# Access Compliance Report

## Public Rights-of-Way

Intersection ID: 42772	Main Street: JEANETTE_CR	Cross Street: SWANSONG_LN	Location:	N
ADA ID: 7C5EF171FAFE	Ramp Type: PerpDiag	Initial Pass/Fail: Fail	Overall Compliance: No	Severity Score: 10
Codes/Mitigation Info/Possible Solution		Field Measurements/Component Compliance

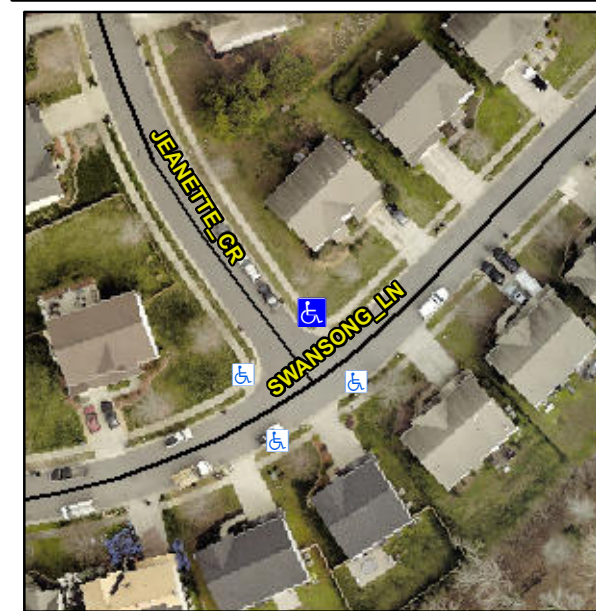
**Not Found, R304.5.1, R304.5.3**

Compliance	Description	Data	Compliance	Description	Data
N/A	Ramp Length (in)	48.0	Yes	Ramp Slope (%)	5.1
No	Ramp Width (in)	38.0	No	Ramp XSlope (%)	4.8
N/A	Flare Type LT	N/A	N/A	Flare Type RT	N/A
N/A	Flare Slope LT (%)	N/A	N/A	Flare Slope RT (%)	N/A
N/A	Flare Traversable LT?	N/A	N/A	Flare Traversable RT?	N/A
N/A	Landing Length (in)	N/A	N/A	DWS Provided?	N/A
N/A	Landing Width (in)	N/A	N/A	DWS Contrast?	N/A
N/A	Landing Slope (%)	N/A	N/A	DWS Length (in)	N/A
N/A	Landing X Slope (%)	N/A	N/A	DWS Full Width?	N/A
N/A	Landing Curb? (Y/N)	N/A	N/A	DWS Offset (in)	N/A
N/A	Shared Landing?	N/A			
N/A	Gutter Ponding?	N/A	N/A	Gutter Slope (%)	N/A
N/A	Gutter Lip Ht (in)	N/A	N/A	Gutter X Slope (%)	N/A
N/A	Painted X Walk1?	No	N/A	Painted X Walk2?	No
	X Walk 1 Direction	To SW		X Walk 2 Direction	To SE
N/A	X Walk 1 Width (in)	N/A	N/A	X Walk 2 Width (in)	N/A
	X Walk 1 Slope (%)	3.7		X Walk 2 Slope (%)	0.5
	X Walk 1 X Slope (%)	1.1		X Walk 2 X Slope (%)	2.4

**Remove & Replace Curb Ramp With Two New Directional Ramps or Equivalent.**
